## APPLICATION FOR SUBMITTAL OF POST-APPROVAL DOCUMENT

**ADDENDUM NO. 1**  
**PROJECT MANUAL**  
**MLK ELEMENTARY SCHOOL**  
**PARENT CENTER**  
**BAKERSFIELD CITY SCHOOL DISTRICT**

**Project No.: 5528**  
**DSA File No. 15-6**  
**DSA App No. 03-122604**  
**December 19, 2024**

Sheet No.: **M3.11**

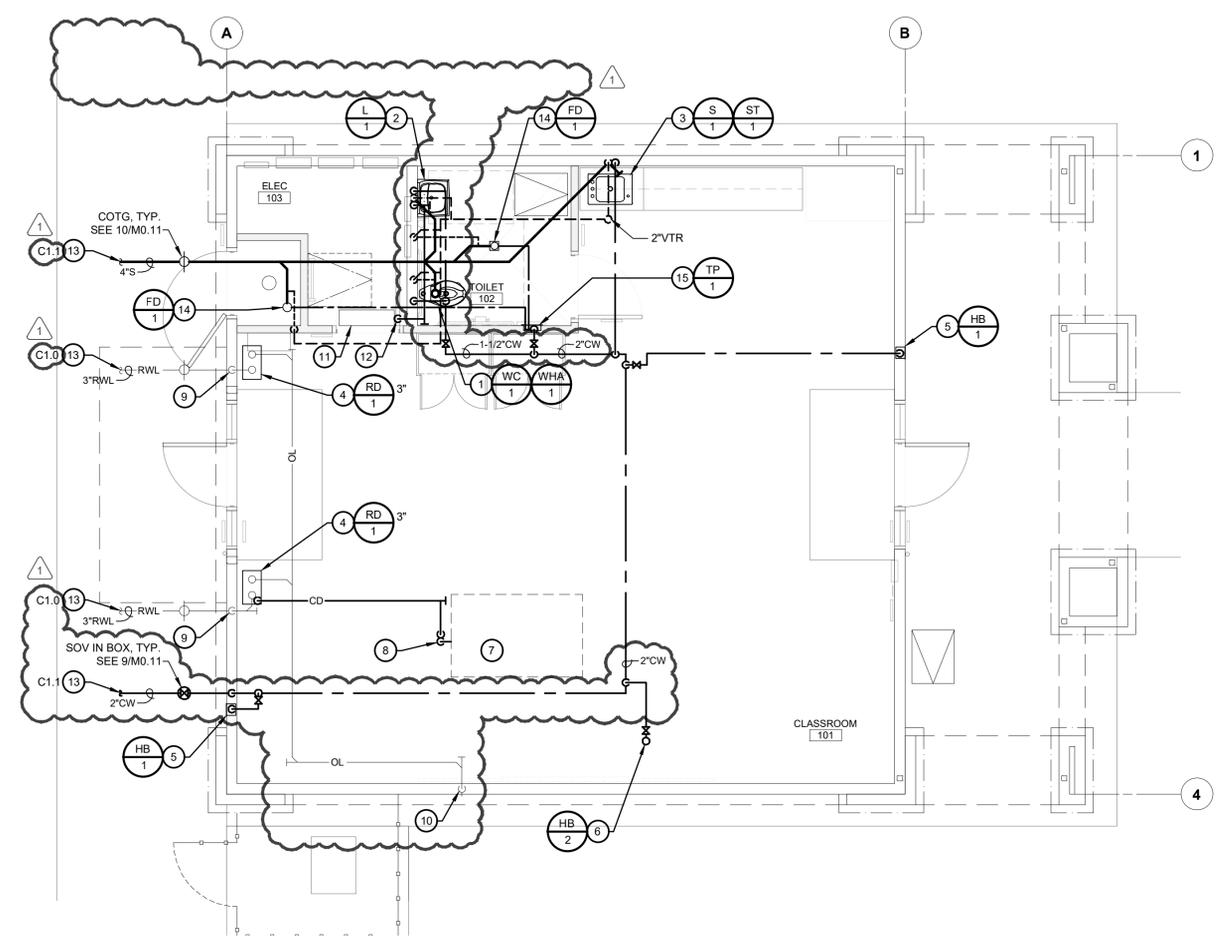
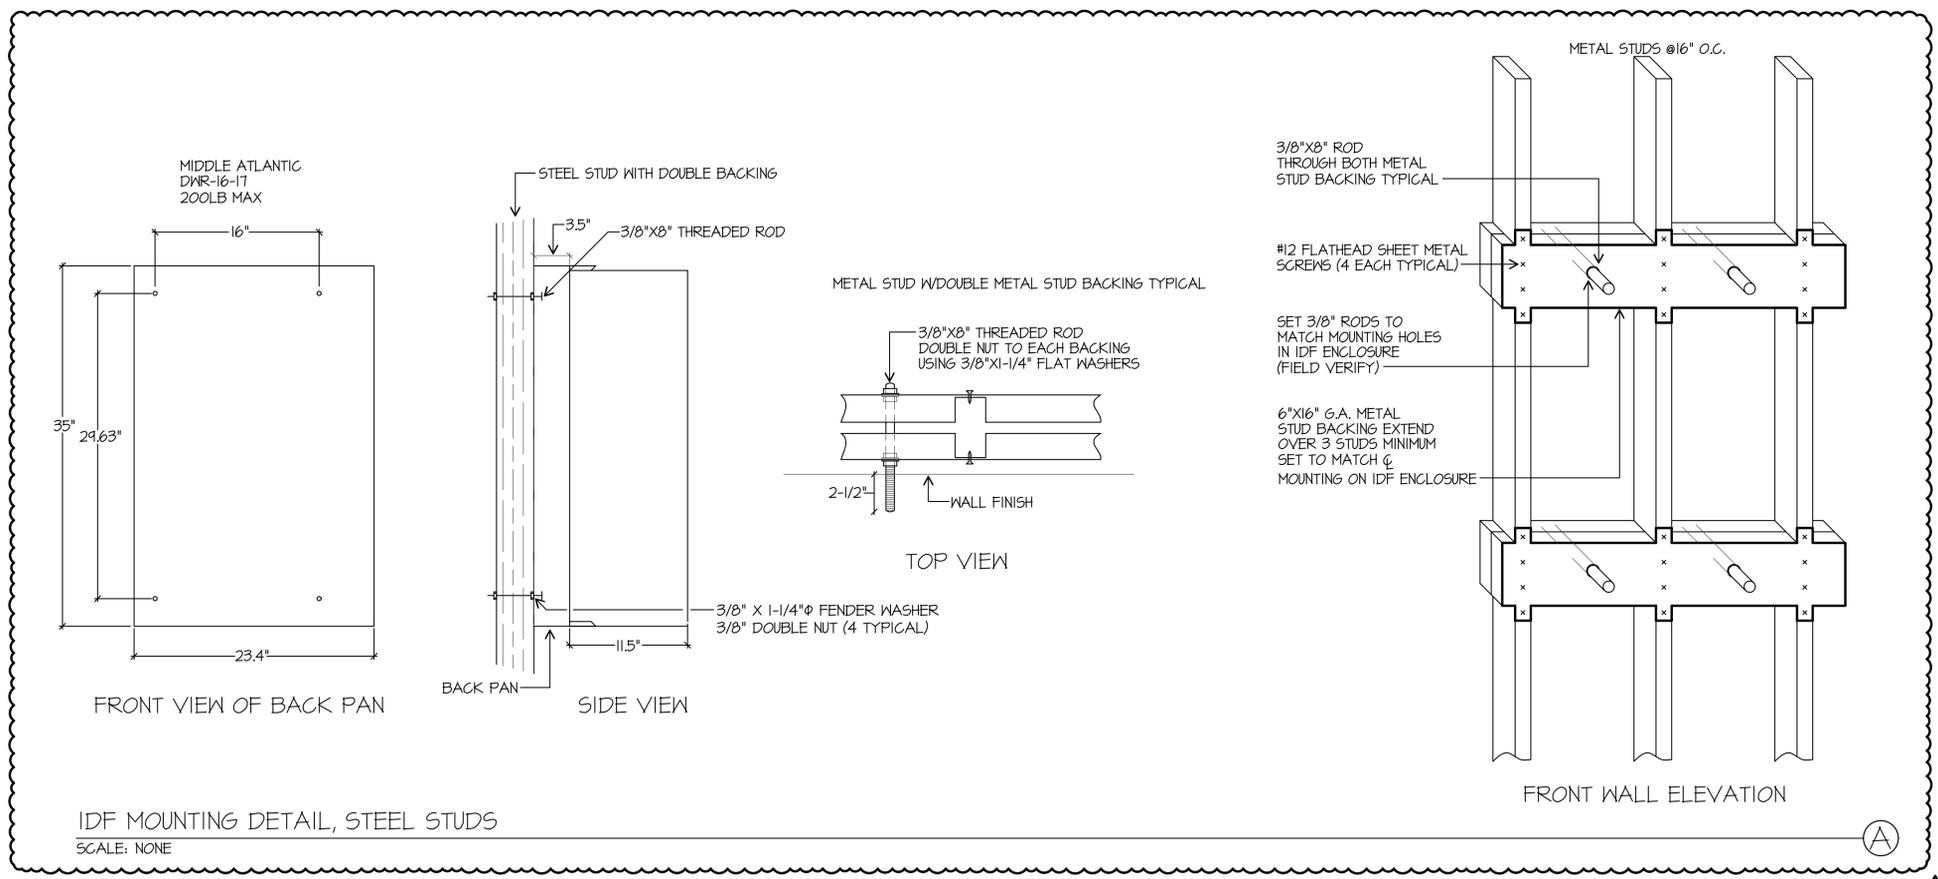
4. Legend have been added.
- 1-30 DRAWING, SHEET M3.11 – PLUMBING PLAN:** Note the following changes (See M3.11 addendum 1 drawing):
1. Point of connection for water line has changed.
  2. Keynotes 3, 8 and 10 have been modified.
  3. Legend has been added.
